TRANSITIONAL PART 3A MAJOR PROJECT-QR NATIONAL TRAIN SUPPORT FACILITY (MP07- 0171)

I refer to the Department's letter of 19 November, 2012 inviting Council to comment on the Environmental Assessment (EA) prepared by ADW Johnson in support of the abovementioned Project.

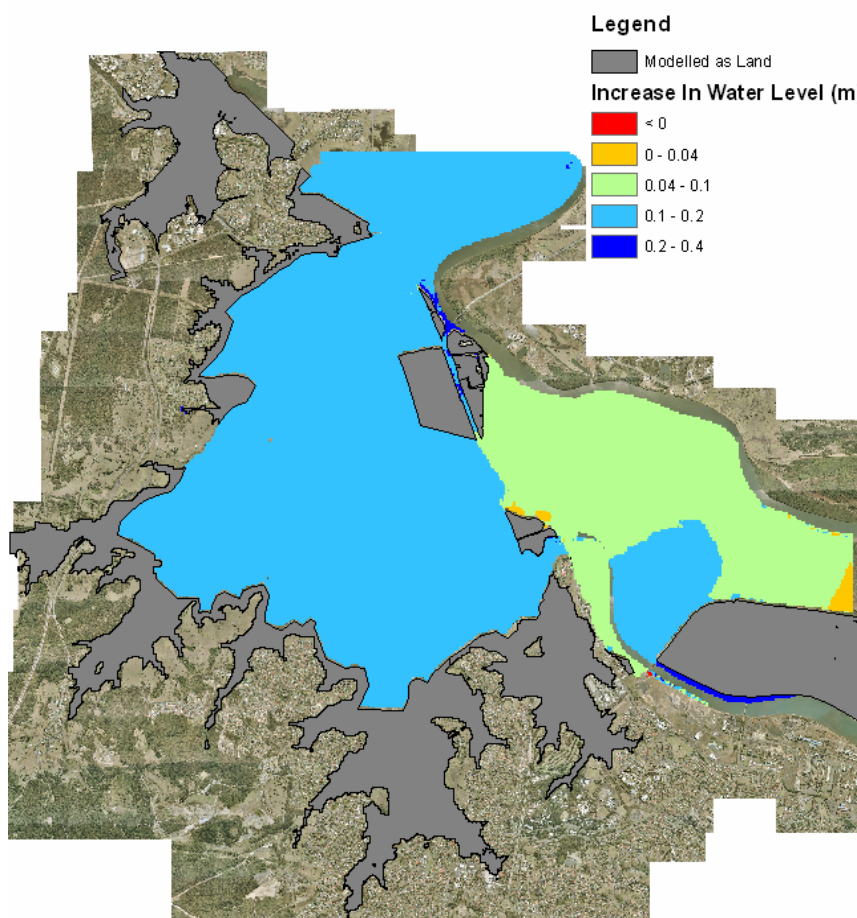
The information in the EA shows that the proposed development will significantly alter the fundamental flow patterns and not retaining the floodway in a condition that is capable for the conveyance of essential flood flow. The Project will increase depths and velocities in a number of areas, contrary to Council's requirements.

It is recommended the proponent is required to address the principles of the NSW Government Floodplain Development Manual (2005) and a flood study is to be prepared to this extent. This Study needs to address a broad range of issues to the same depth as the existing management plan and associated studies. Cumulative impact must be addressed at the global rather than the development specific level.

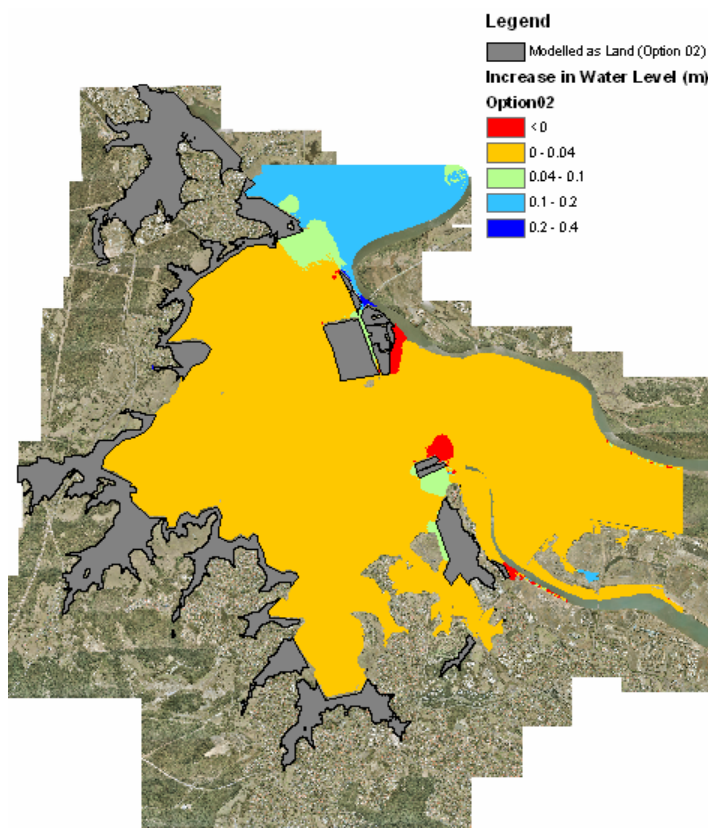
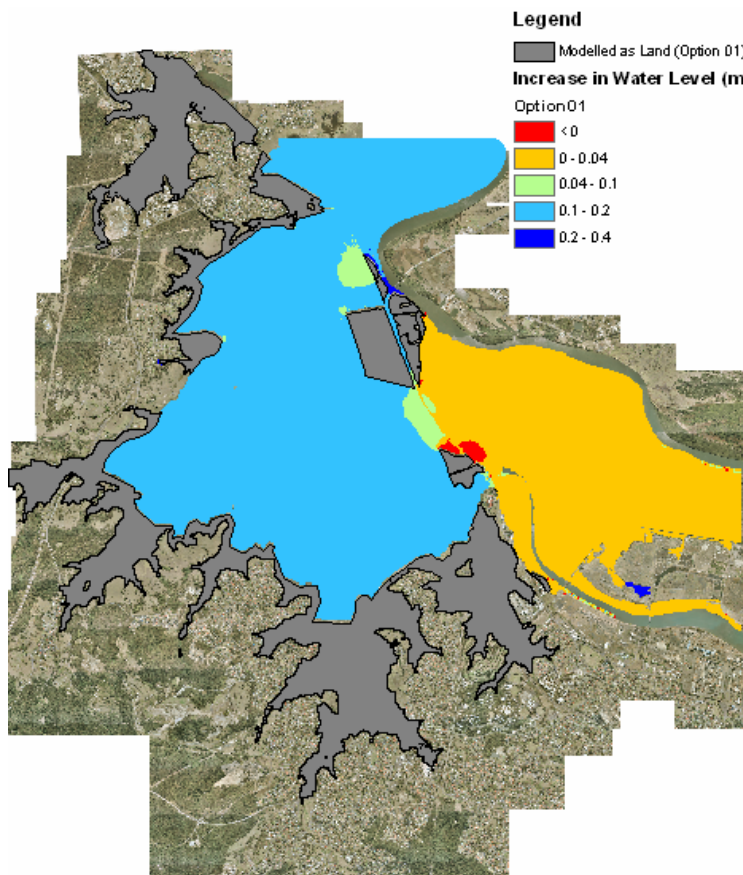
Inadequate information has been provided of the affects upstream and down stream. Modelling of filling on that part of Hexham revealed impacts on the flows up stream in the Hunter River, Hexham, Hexham swamp, as well as on Kooragang Island. Refer to the fill scenarios below:

While the above modelling did not include the fill for a rail line and the associated works in them, they do demonstrate that the filling and potential blocking of the floodway and limiting the flows down stream can have impacts on a wider catchment.

Design changes are required to the Project to ensure that there is no increased impacts (or minimum increases within acceptable limits) within the Hunter River flood plain for all flood events.
